Model: Kir-C Fax Option		Date: 31-May-01	No.: MB404001
Modified Article: Parts Catalog Correction		Prepared by: K. Miura	
From: Technical Services Dept., GTS Division			
Reason for Modification:	<input checked="" type="checkbox"/> Parts catalog correction <input type="checkbox"/> To facilitate assembly <input type="checkbox"/> Part standardization	<input type="checkbox"/> Vendor change <input type="checkbox"/> To improve reliability <input type="checkbox"/> Other	<input type="checkbox"/> To meet standards ()

Please correct your Parts Catalog as follows:

Page 3

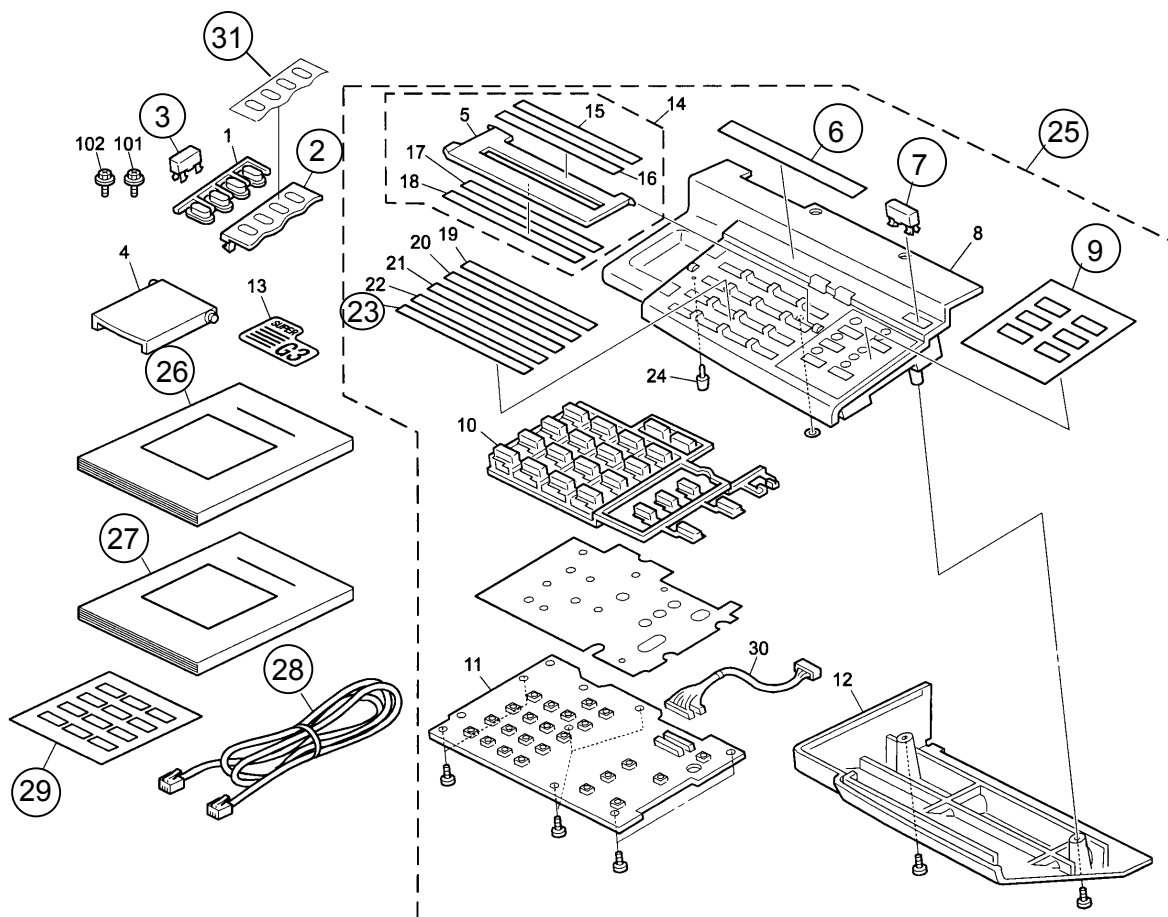
- Description Changes -

Part number	Old description	New description	Q'ty	Index	Note
B4041482	Switch Cover (EU)	Switch Cover (EU/CHN/TWN)	1	2	
B4041483	Copy Key (EU)	Copy Key (EU/CHN/TWN)	1	3	
B4041455	Sheet Fax	Sheet Fax (NA/Asia)	1	6	
B4041480	Fax Key (EU)	Fax Key (EU/CHN/TWN)	1	7	
B4041456	Sheet Function	Sheet Function (NA/Asia)	1	9	
B4041467	Decal Dial Lower	Decal Dial Lower (NA/Asia)	1	23	
B4041422	Operation Panel (EU)	Operation Panel (EU/CHN/TWN)	1	25	
H5235350	Telephone Cable	Telephone Cable (NA)	1	28	
B4041476	User Function Key Decal	User Function Key Decal (NA)	1	29

- Additions -

Part number	Description	Q'ty	Index	Note
B4048606	Operation Manual (CHN)	1	26	
B4048609	Operation Manual (TWN)	1	26	
B4048656	Operating Instructions – Advanced (CHN)	1	27	
B4048659	Operating Instructions – Advanced (TWN)	1	27	
B4041487	User Function Key Decal (CHN)	1	29	
B4041489	User Function Key Decal (TWN)	1	29	
B4041488	Function Sheet (CHN)	1	31	
B4041486	Function Sheet (TWN)	1	31

Page 5

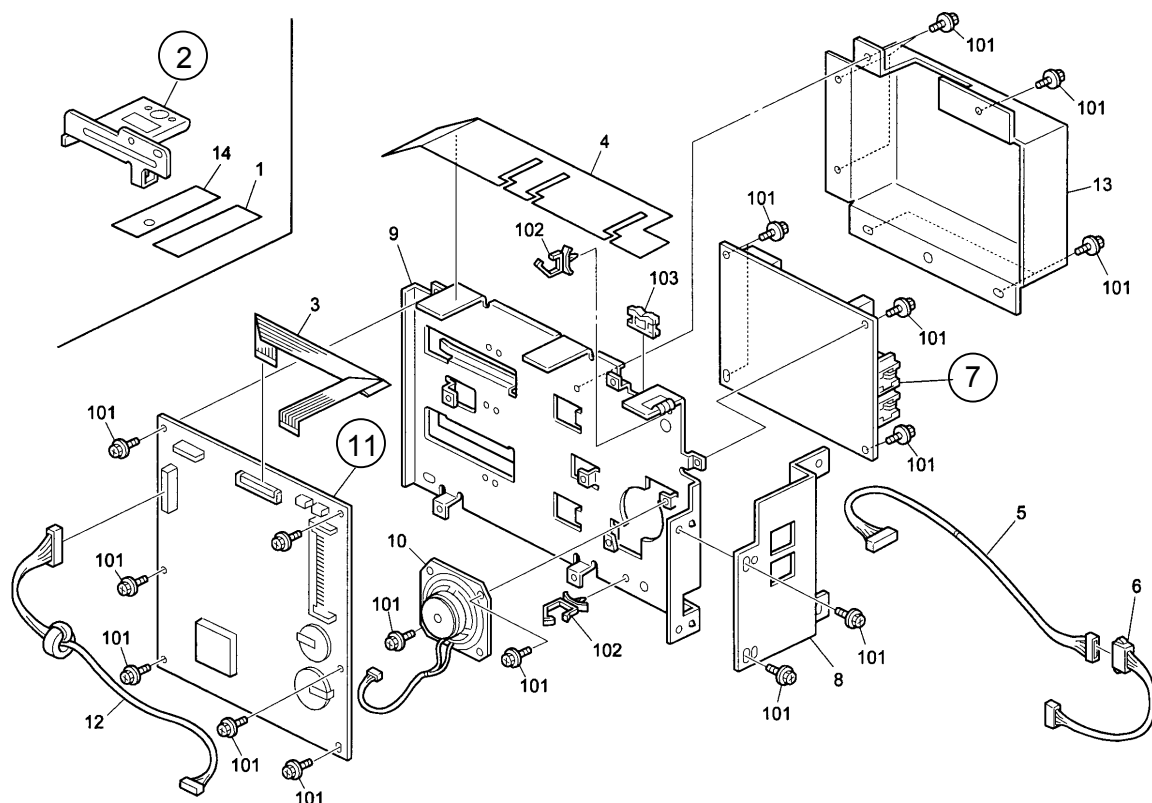
- Description Changes -

Part number	Old description	New description	Q'ty	Index	Note
B4045821	Handset Bracket	Handset Bracket (NA)	1	2	
B4045184	NCU Board (EU)	NCU Board (Except for NA)	1	7	
B4045166	FCU Board (Asia)	FCU Board (Asia/CHN/TWN)	1	11

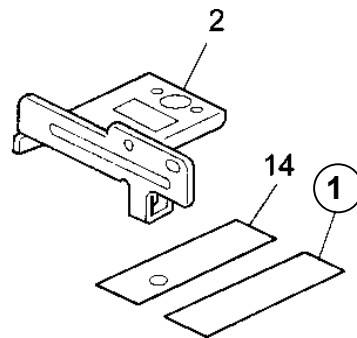
To facilitate the flat cable, the following part has been changed:

Old part number	New part number	Description	Q'ty	Int	Page	Index	Note
B4045862	B4045875	Right Flat Cable Plate	1	O/O	5	1

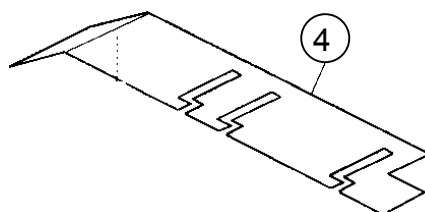
To prevent incorrect routing of the flat cable, the following part has been changed:

Old part number	New part number	Description	Q'ty	Int	Page	Index	Note
B4045874	B4045876	Flat Cable Bracket	1	X/O	5	4

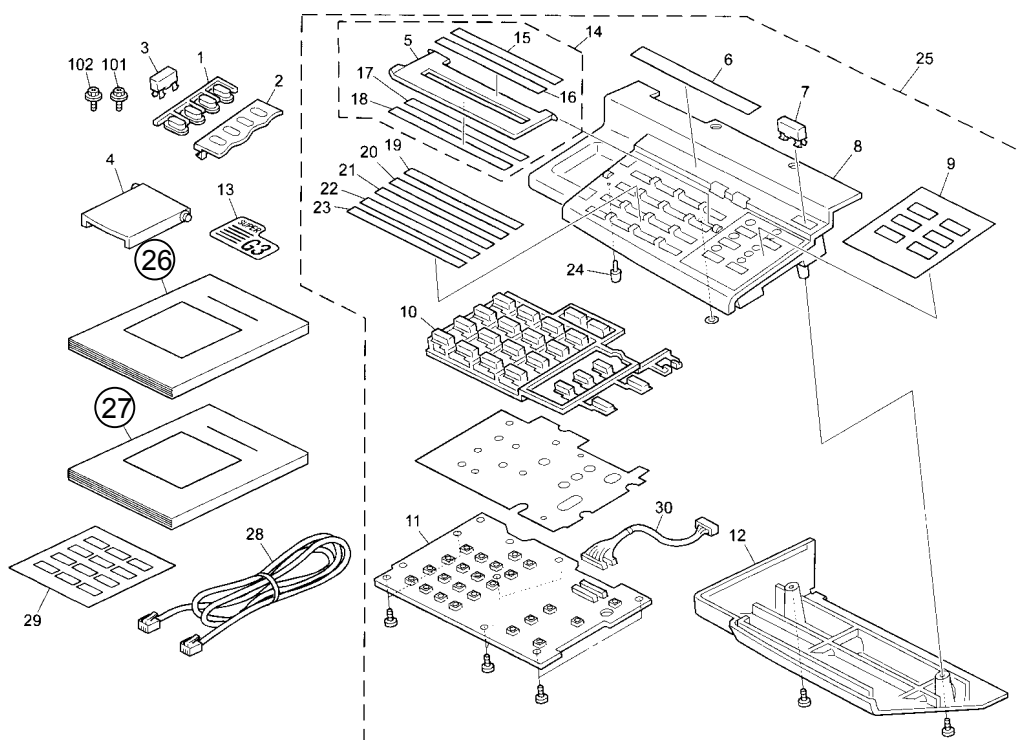
To include the duplex machine information into the Operating Instructions, the following parts have been changed:

Old part number	New part number	Description	Q'ty	Int	Page	Index	Note
B4048607	B4048611	Operation Manual (NA)	1	X/O	3	26	
B4048657	B4048660	Operating Instructions Advanced (NA)	1	X/O	3	27
